Docket Item # 8  
BAR CASE # 2008-0168

BAR Meeting  
December 17, 2008

**ISSUE:** Alterations  
**APPLICANT:** Elizabeth Reno and Roy Wuchitech  
**LOCATION:** 408 North Union Street  
**ZONE:** RM/Residential

**STAFF RECOMMENDATION:** Staff recommends deferral of the application for restudy.

Figure 5: Overlay comparing submission for 10/15/2008 BAR hearing with submission for 12/17/2008 BAR hearing.

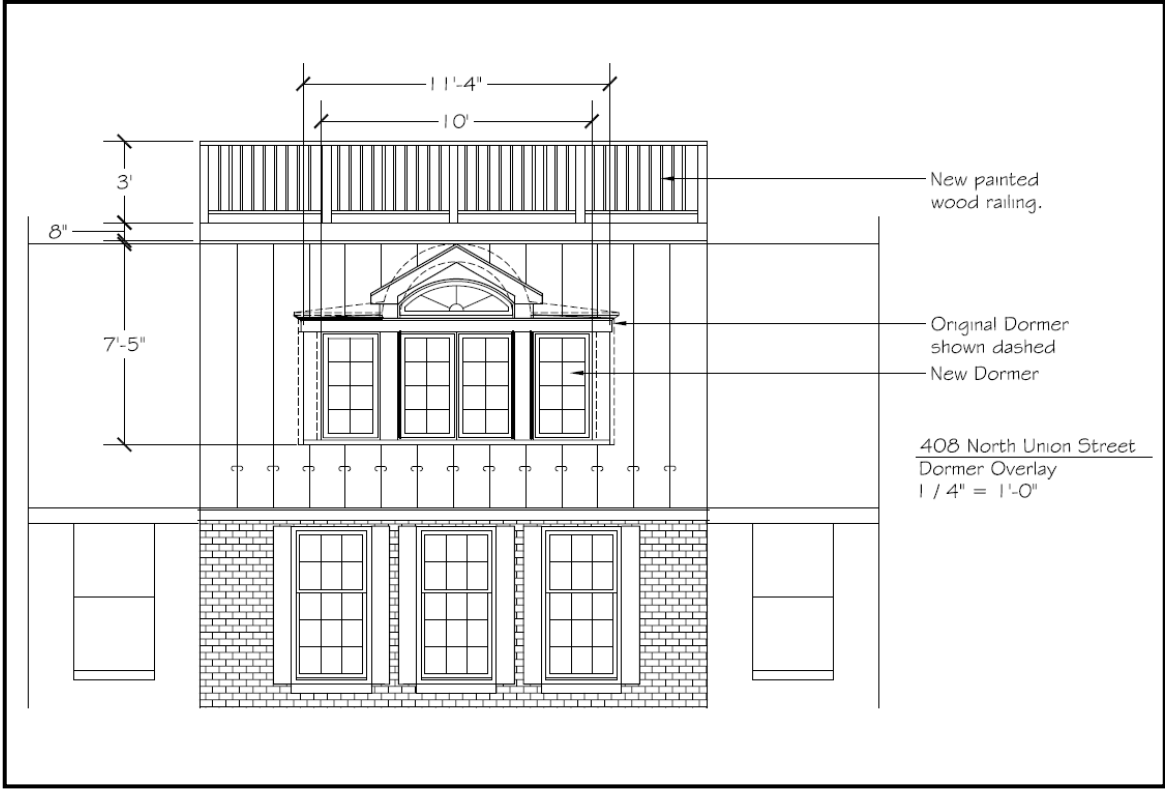
According to the *Design Guidelines*, when installing a new dormer “The style of the dormer should be appropriate to the architectural style of the existing structure.” In Staff’s opinion, because the houses in this development along North Union are not historic and some have experienced alterations, including new Palladian-style windows of differing styles, Staff does not conceptually have an objection to alterations to this property, which may include a new dormer or roof top deck. However, with the current proposal, the size of the new dormer is almost identical to the one submitted for the October 15<sup>th</sup> hearing. As originally submitted for the October hearing, the drawing showed the total width of the dormers as 10’4,” however upon clarification by the applicant for the current submittal, the measurement on the drawing provided did not include exterior trim on the outside of the windows, therefore the proposed dormers submitted on September 12, 2008 was in fact approximately 11’8” in total width. Based on this corrected information, the width of the proposed dormer submitted to Staff on December 10, 2008 is 4” narrower than the original submission. In terms of the height, upon clarification by the applicant the original dimension of 6’ on the drawing did not include any trim work and therefore the total height of the dormers, including trim, measured 7’5” rather than 6’. The revised submission for the December 17<sup>th</sup> hearing maintains the 7’5” height measurement. From the corrected information provided by the applicant, the current dormer has been reduced in width by 4” but has not been reduced in height from the October submittal.

As stated above, Staff is concerned that the current proposal for the new dormers does not adequately address the concerns of the Board from the October hearing in respect to the appropriateness, style and the mass of the proposed Palladian-style windows. While the design of the dormer has been altered from the prior rounded form, the size and scale of the dormer has not been sufficiently revised to address the concerns expressed by the Board. Therefore, Staff recommends deferral of the application for restudy.
